Alterations to Stage 1B basement, Barangaroo South

State Significant
Development Modification
Assessment
(SSD 6960 MOD 1)

April 2019

Figure 6 | The approved (left) and proposed (right) location of the Building R5 core on Basement Level B0 (Base Source: RPBW Architects)

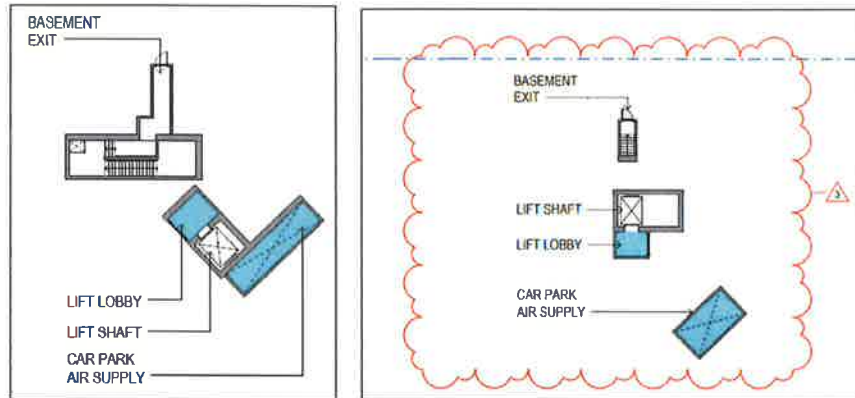
The modification application seeks approval to revise the location of the Building R5 core. This results in minor changes to the basement levels B0, B1, B2, B3, B4, B5 and ground floor (**Figures 5 and 6**). The Applicant notes the design of Building R5, including the floorplate configuration, has been revised in response to submissions received in SSD 6966. The Applicant therefore notes the modification application will ensure the ground floor and basement levels are consistent with these above-ground design changes.

The Department notes the design changes under SSD 6966 necessitate a modification to SSD 6960 to align with the Building R5 core. The Department also notes the revised location of the core is within the Stage 1B basement and would not require any additional excavation or remediation works and would not result in any adverse environmental impacts. The Department therefore concludes the relocation of the Building R5 core would ensure consistency with SSD 6966 and is acceptable.

Figure 7 | The approved (left) location and proposed (right) layout of the ground floor elements due to relocation of the Building R5 core (Base Source: RPBW Architects)

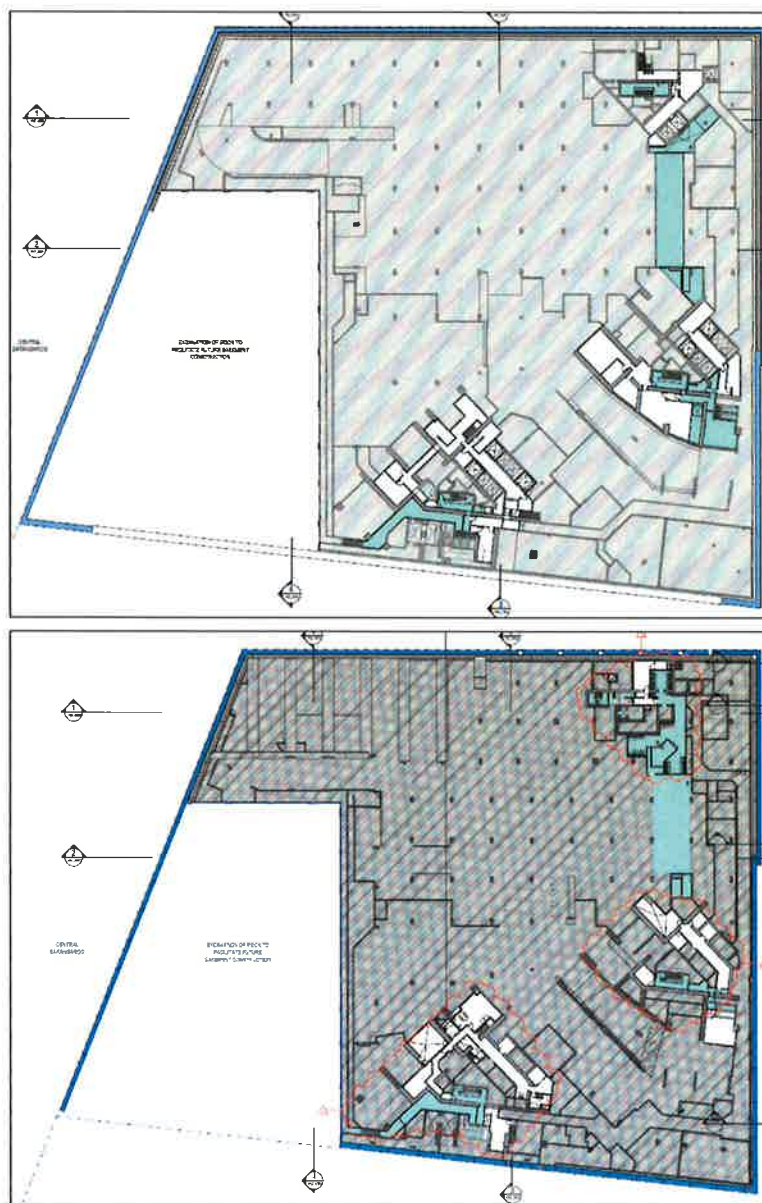
The modification application also seeks ancillary amendments to the basement levels, including revision of the plant room layout and relocation of the basement structural columns (**Figure 7**).

The Department notes the proposed amendments to the plant room layout and structural grid are warranted by the revised location of the Building R5 core and would not result in any adverse operational or structural impacts. The Department therefore concludes this element of the modification application is supported.
